The Barn,
Great North Road,
Radwell,
Baldock,
Hertfordshire,
SG7 5EN
By email only

Reference: The Barn, Great North Road, Radwell, Baldock, Hertfordshire, SG7 5EN

1.0 Introduction and Background

This report reviews the lighting installation from an ecological perspective, with reference to Guidance Note 08/23: Bats and Artificial Lighting at Night, produced by the Bat Conservation Trust and Institution of Lighting Professionals.

Figure 2: Lighting Plan.

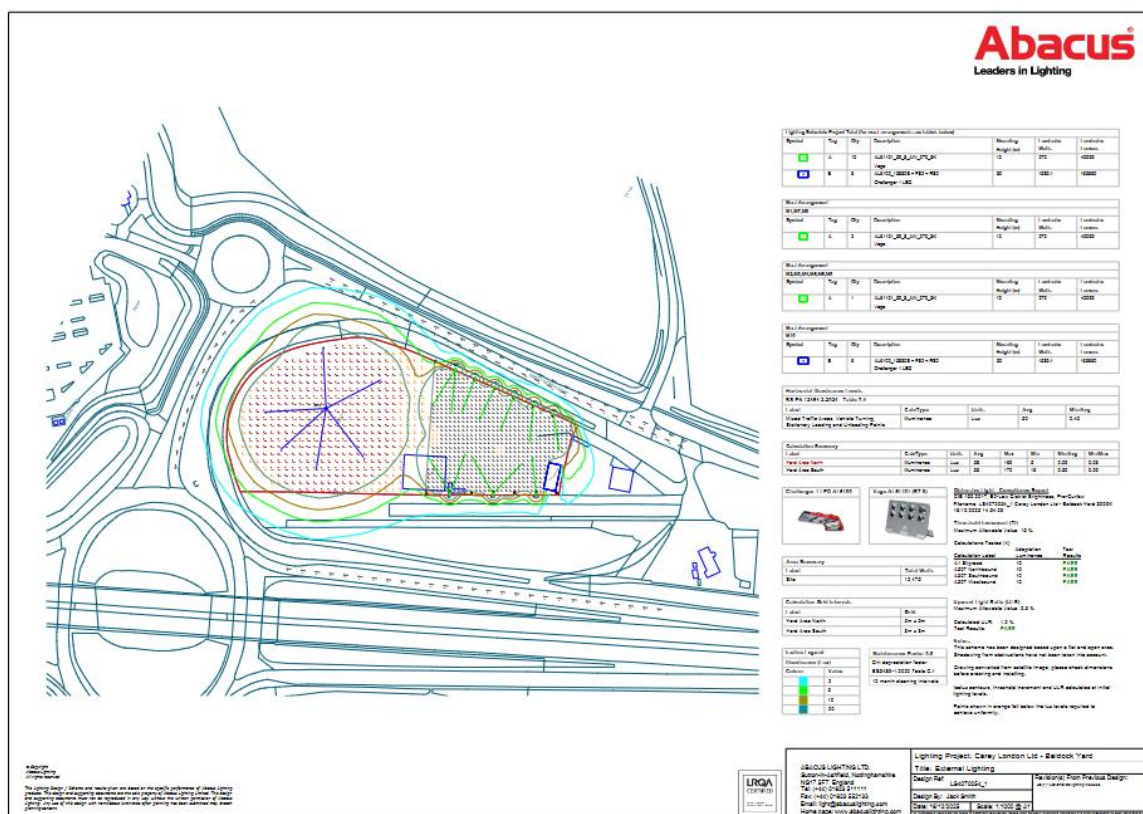
The key issue is the 30 m mast. Its elevated mounting height increases the potential for light spill and visible glare beyond the operational yard. This is consistent with the Environmental Protection Officer's observation of visible illumination of surrounding vegetation and measured levels slightly exceeding the submitted lighting model.

Where practicable, the height of the mast should be reduced and/or the Challenger 1 luminaires should be re-aimed or fitted with additional shielding or other optical controls to reduce light spill onto surrounding vegetation.

- retain the existing seasonal and time-based restrictions on operation of the 30 m mast;
- reduce the height of the mast where practicable without substantially increasing operating hours;
- refine luminaire aiming and shielding to minimise light spill and glare;

- avoid direct illumination of bat boxes and retained woodland or vegetation wherever practicable; and
- consider a reduction in colour temperature where operationally practicable.
